# Access Compliance Report

## Public Rights-of-Way (Curb Ramps)

Intersection ID: 25441	Main Street: PROVIDENCE PLANTATION LN	Cross Street: PROVIDENCE SPRING LN	Location: SW
ADA ID: B68EDDB409B8	Ramp Type: Perp	Initial Pass/Fail: Fail	Overall Compliance: No
Severity Score: 8.75			
Codes/Mitigation Info/Possible Solution		Field Measurements/Component Compliance

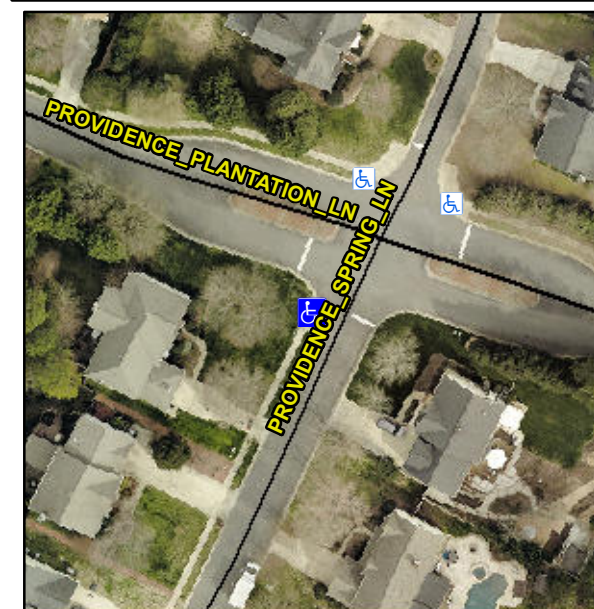
**Not Found, R304.5.1**

Compliance	Description	Data	Compliance	Description	Data
N/A	Ramp Length (in)	51.0	Yes	Ramp Slope (%)	5.8
No	Ramp Width (in)	44.0	Yes	Ramp XSlope (%)	1.5
N/A	Flare Type LT	N/A	N/A	Flare Type RT	N/A
N/A	Flare Slope LT (%)	N/A	N/A	Flare Slope RT (%)	N/A
N/A	Flare Traversable LT?	N/A	N/A	Flare Traversable RT?	N/A
N/A	Landing Length (in)	N/A	N/A	DWS Provided?	N/A
N/A	Landing Width (in)	N/A	N/A	DWS Contrast?	N/A
N/A	Landing Slope (%)	N/A	N/A	DWS Length (in)	N/A
N/A	Landing X Slope (%)	N/A	N/A	DWS Full Width?	N/A
N/A	Landing Curb? (Y/N)	N/A	N/A	DWS Offset (in)	N/A
N/A	Shared Landing?	N/A			
N/A	Gutter Ponding?	N/A	N/A	Gutter Slope (%)	N/A
N/A	Gutter Lip Ht (in)	N/A	N/A	Gutter X Slope (%)	N/A
N/A	Painted X Walk1?	No	N/A	Painted X Walk2?	N/A
	X Walk 1 Direction	To NE		X Walk 2 Direction	N/A
N/A	X Walk 1 Width (in)	N/A	N/A	X Walk 2 Width (in)	N/A
	X Walk 1 Slope (%)	2.8		X Walk 2 Slope (%)	N/A
	X Walk 1 X Slope (%)	1.4		X Walk 2 X Slope (%)	N/A

**Remove & Replace Entire Ramp.**
